MAGNASTOR[®]

FINAL SAFETY ANALYSIS REPORT

**NAC INTERNATIONAL
RESPONSES TO THE
UNITED STATES
NUCLEAR REGULATORY COMMISSION
REQUEST FOR ADDITIONAL INFORMATION #1**

**MAGNASTOR® FSAR
RAI Responses for Amendment 10
Revision 21A**

Figure 3.11.4-5 Acceleration Time Histories at Top of the Basket and TSC Lid for MSO Tip-over Event

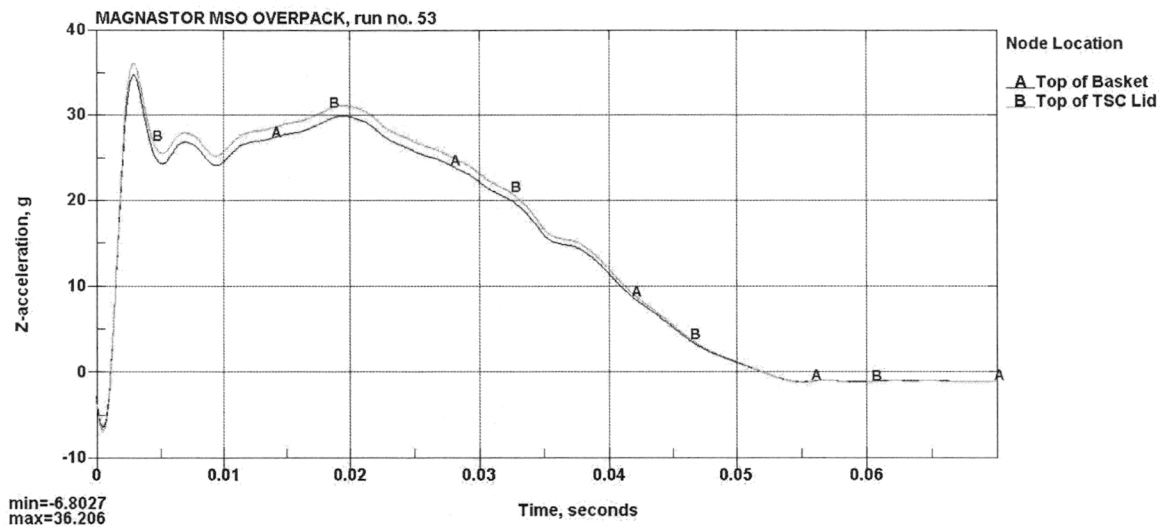
- 3-3. Justify the assumption that the MSO will behave as a cantilever beam when determining the natural frequency of the MSO in Appendix A to Calculation Package No. 30082-2605, "Tip-Over Analysis for the MAGNASTOR Metal Storage Overpack (MSO)."

The stress analysis for the non-mechanistic tip-over provided on page 30 of the calculation package considers the MSO to be a simply supported beam with a triangular loading applied when striking the pad. However, this calculation applies a dynamic load factor that is derived from the natural frequency of the MSO calculated in Appendix A, which assumes a cantilever beam behavior. The staff notes that the LS-DYNA model that simulates tip-over produces the largest accelerations when the bottom lip of the MSO and tip of the MSO are in contact with the pad, resembling more closely a simply supported beam. Looking at Figure 6.1.5-1 of Calculation Package 30082-2605, the staff believes that the dynamic load factor determined from assuming a cantilever beam behavior may be non-conservative when a simply supported beam assumption appears to be more appropriate for the boundary conditions of the MSO when striking the pad. The staff requests justification of the assumption of cantilever beam behavior in the tip-over stress analysis and that the calculations and FSAR be updated with the appropriate dynamics load factor as necessary.

The calculation of the fundamental mode of the MSO has been updated using a pinned-free boundary condition, which is considered to be more appropriate than a cantilevered assumption. Also, the resulting fundamental frequency of pinned-free beam is higher than both a cantilevered and simply supported beam, and this results in a higher filtering frequency to be applied to the accelerations time histories, which is conservative. In addition, the methodology for calculating the MSO frequency has been modified by treating the MSO as a single composite beam comprised of the inner and outer liners. Both bending and shear effects are considered, and the calculated fundamental frequency of the MSO is 189 Hz. A filter frequency of 200 Hz is applied to the nodal accelerations from the solution results. Using the revised acceleration and pulse duration, the DLF has been updated.
